MONTGOMERY COUNTY DEPARTMENT OF PARK AND PLANNING

OPINION

#9-98005A

Downtown Silver Spring

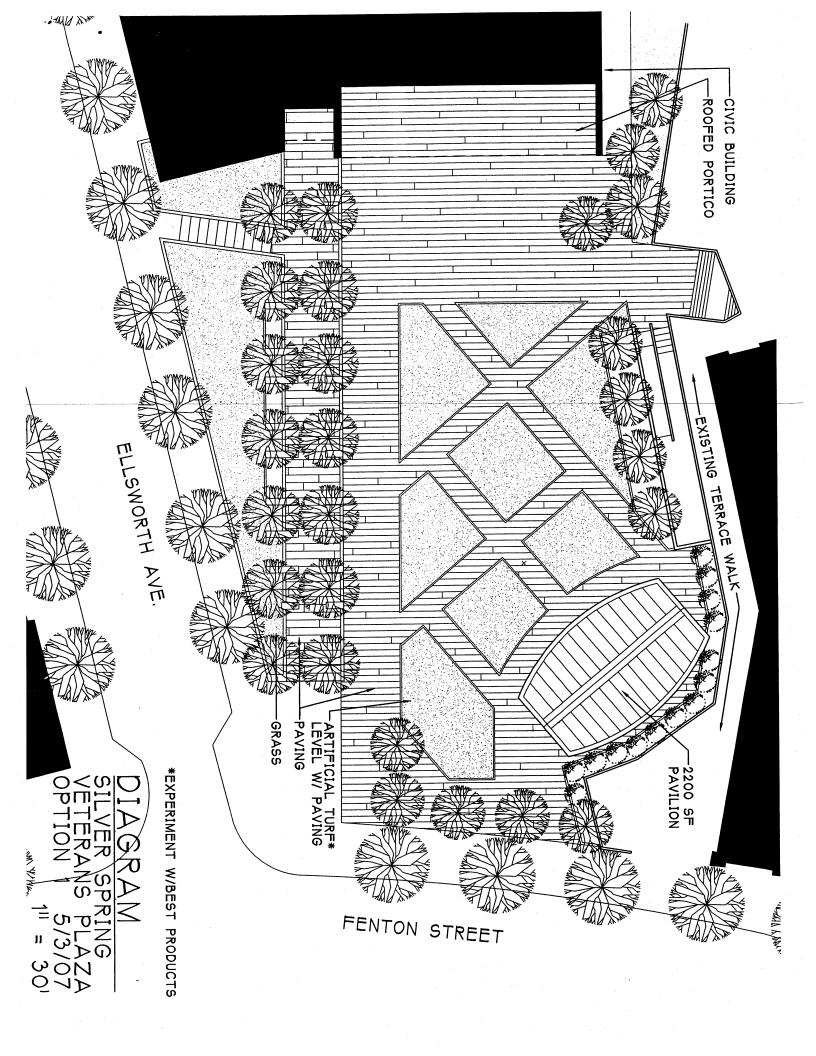
Negatives: The rink is expensive to build and maintain, consumes a lot of non-renewable energy. It consumes a lot of space in the winter for an activity that has not been shown to be a high priority for the residential community. Because the plaza site is sloped and the rink has to be flat and is to be accessible from the rooms below Adega, the rink is placed three steps down from the rest of the plaza and a lot of space and money are used to provide access to the rink. Skaters will be charged to skate and to rent skates, thus taking what should be a free public space and making it a fee required space in the winter (the charge at the Pentagon Row rink is \$8). Furthermore, the nearby Wheaton Ice Arena currently operates at a loss. If the proposed rink reduces the number of users at that rink, the County will lose more money.

Solution: My preference is to move the ice rink to the proposed open space at the upcoming library site at the intersection of Fenton Street and Wayne Avenue. This is a flat site that will easily accommodate the large rink and roof, and at that location it will serve to draw young people to the library. Alternatively, make the rink smaller. The proposed rink is nearly 7000 square feet in size. The new rink near Pentagon City is only about 4000 square feet and has so far been financially successful. A smaller rink would allow for far more open green space and would allow for the public space to be used as public plazas have been traditionally used, for community-building. Other amenities and events to activate the plaza in the winter should be included in the design and programming (fire pit, heated seating, hot food kiosks, ice carving festival, etc.).

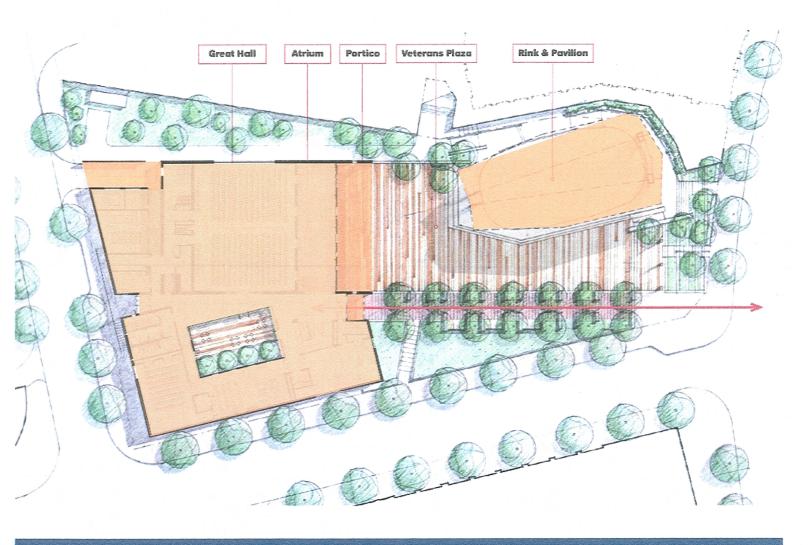
When asked, most of the residents we've surveyed have indicated that they had no idea that the roofed rink/pavilion is to be so large and the remaining plaza area so small. As they have learned about the current plan, most have indicated that they prefer more open space rather than the roofed rink/pavilion. As you know, the MNCPPC planning staff have also spoken up and suggested that the ice rink be deleted from the scope in favor of more open space. This creates an opportunity for the community to reconsider and build a better public space.

I have attached two diagrams. One shows the currently proposed scheme, with the pavilion roof shown in orange. The second diagram shows most of the plaza unchanged, but indicates a civic green in the area of the plaza that would be available if the pavilion is not built. The civic green could easily be made of a high quality artificial turf that would be more durable than grass or the existing temporary astroturf. Please take a moment to review these options.
